**G.U.S.C. OF THE CITY OF BESSEMER, ALABAMA  
WATER TREATMENT PLANT IMPROVEMENTS  
CHEMICAL/SHOP BUILDING MODIFICATIONS  
AND NEW MAINTENANCE BUILDING**

**ADDENDUM TO THE PLANS AND SPECIFICATION-CONTRACTUAL DOCUMENTS**

**ADDENDUM NO. 2**

## TYPICAL REINF. AT MASONRY WALL OPENINGS

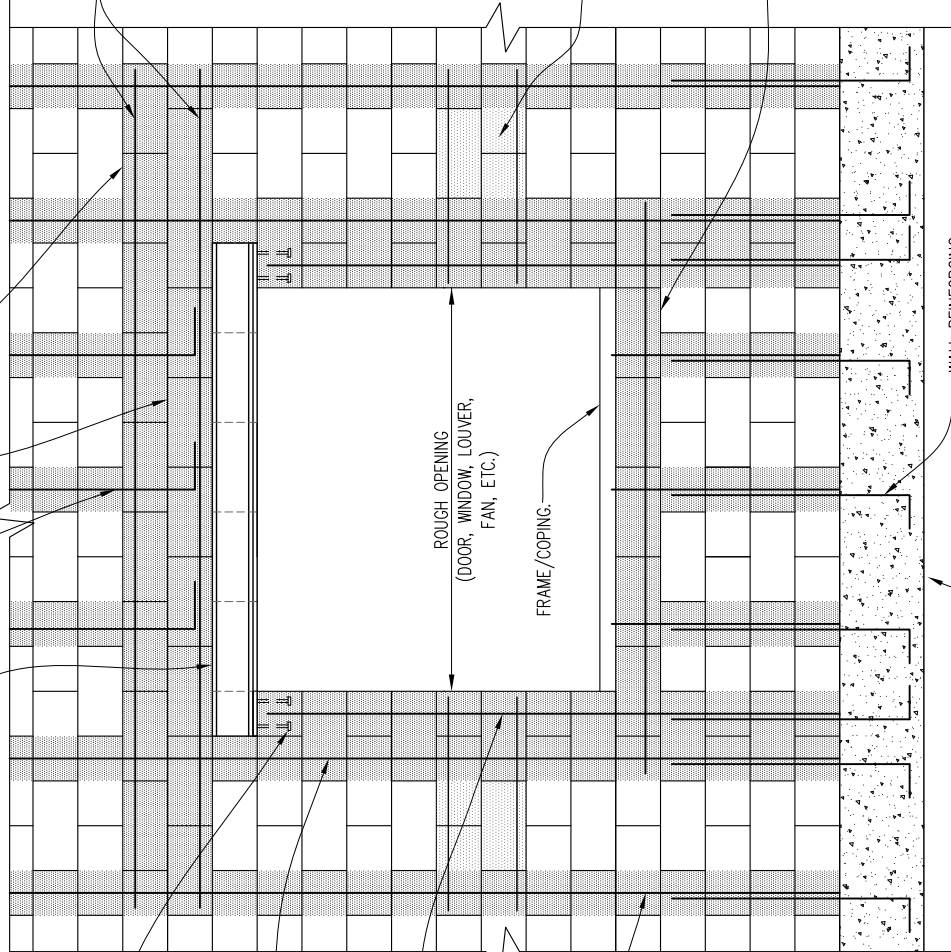
5. Re: Sheet 16, TYPICAL REINF. AT MASONRY WALL OPENINGS detail  
Revision: Replace this detail with the attached detail for **"TYPICAL REINF. AT MASONRY WALL OPENINGS"**

TWO COURSE, MASONRY BOND BEAM REQUIRED ABOVE STEEL LINTEL (EXCEPT USE SINGLE COURSE BOND BEAM WHEN TOP OF OPENING IS LOCATED WITHIN 40" OF THE BOND BEAM WHERE THE ROOF TRUSSES ARE ANCHORED). FIRST COURSE TO BE CONCRETE-FILLED, OPEN BOTTOM U-BLOCK/LINTEL BLOCK WITH TWO #5 REBAR IN BOTTOM. PROVIDE HOT-DIPPED GALV. MESH UNDER BOND BEAM AT LOCATIONS WHERE CELLS BELOW HAVE NO VERTICAL REBAR AND ARE NOT TO BE FILLED WITH GROUT/CONCRETE. SECOND COURSE TO BE CONCRETE-FILLED, OPEN BOTTOM U-BLOCK/LINTEL BLOCK WITH TWO #5 REBAR NEAR TOP. FOR OPENINGS LESS THAN OR EQUAL TO 6 FT WIDE, EXTEND BOND BEAM HORIZONTALLY TO THE FIRST VERTICALLY REINFORCED CELL "COLUMN" BEYOND END OF STEEL LINTEL, EACH END. FOR OPENINGS GREATER THAN 6 FT. WIDE, EXTEND BOND BEAM HORIZONTALLY TO THE SECOND VERTICALLY REINFORCED CELL "COLUMN" LOCATED BEYOND END OF STEEL LINTEL AS SHOWN, EACH END.

TWO #6 VERT. IN SECOND ADJACENT CELL EACH SIDE OF OPENING - FROM FOOTING WALL TO BOND BEAM AT ROOF

TWO #6 VERT. IN FIRST CELL EA. SIDE OF OPENING - FROM FOOTING WALL TO UNDERSIDE OF STEEL LINTEL BEARING PLATE

FOR OPENINGS WIDER THAN 7 FT AND TALLER THAN 7 FT, PROVIDE ADDITIONAL DOUBLE COURSE BOND BEAM W/TWO #5 HORIZONTAL REBAR T&B (SIMILAR TO OTHER BOND BEAMS) EACH SIDE OF OPENING AT MID-HEIGHT OF OPENING.

PROVIDE BOND BEAM BENEATH ELEVATED OPENINGS. BOND BEAM SHALL BE CONCRETE-FILLED, OPEN BOTTOM LINTEL BLOCK WITH TWO #5 HORIZONTAL REBAR. PROVIDE HOT-DIPPED GALV. MESH UNDER BOND BEAM AT LOCATIONS WHERE VERTICAL CELLS BELOW HAVE NO REBAR AND ARE NOT TO BE CONCRETE/GROUT FILLED. FOR OPENINGS ELEVATED MORE THAN 10' A.F.F., PROVIDE DOUBLE COURSE BOND BEAM WITH TWO ADDITIONAL #5 HORIZONTAL REBAR. EXTEND DOUBLE COURSE BOND BEAM HORIZONTALLY TO THE THIRD CONCRETE-FILLED VERTICAL CELL "COLUMN" LOCATED EACH SIDE OF OPENING.

# ROLL-UP DOOR - JAMB PROTECTION DETAIL

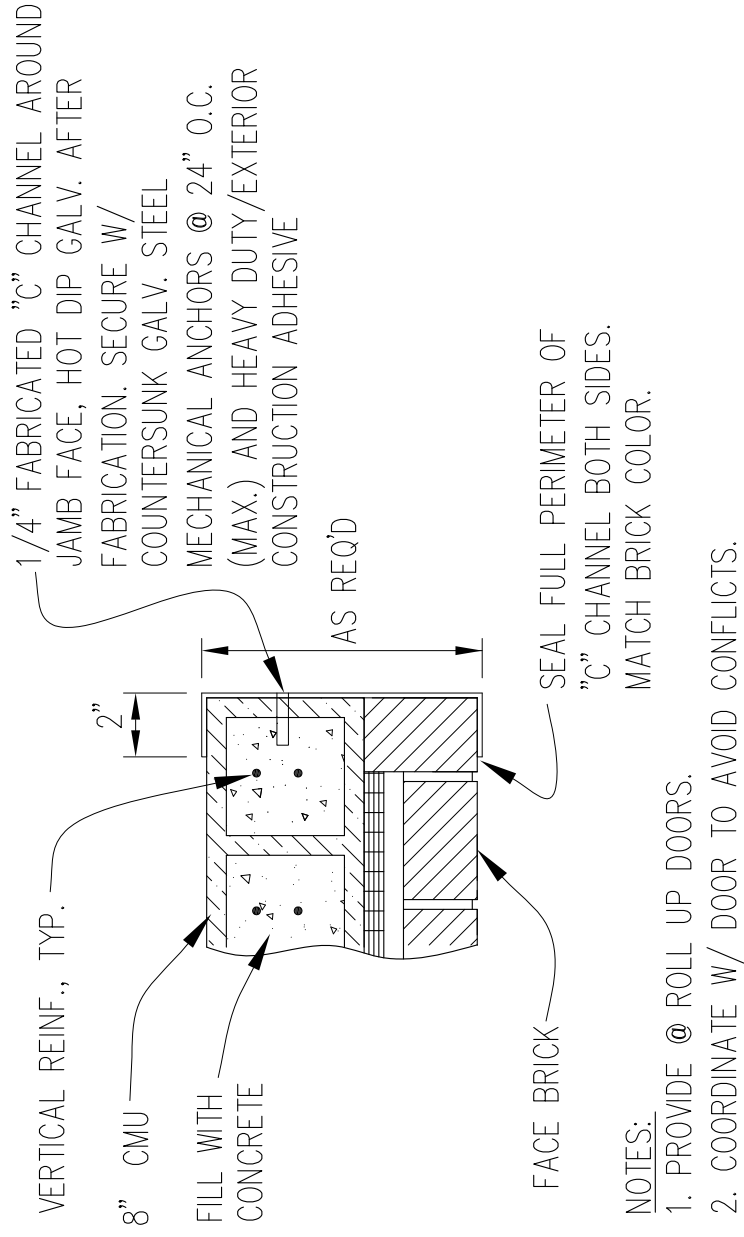
6. Re: Sheet 18  
Addition: Add the attached detail named **"ROLL-UP DOOR - JAMB PROTECTION DETAIL"** to Sheet 18. This detail applies to the required jamb protection at both the roll-up doors (D1 and D6) at the New Maintenance Building.

- NOTES:
1. PROVIDE @ ROLL UP DOORS.
  2. COORDINATE W/ DOOR TO AVOID CONFLICTS.
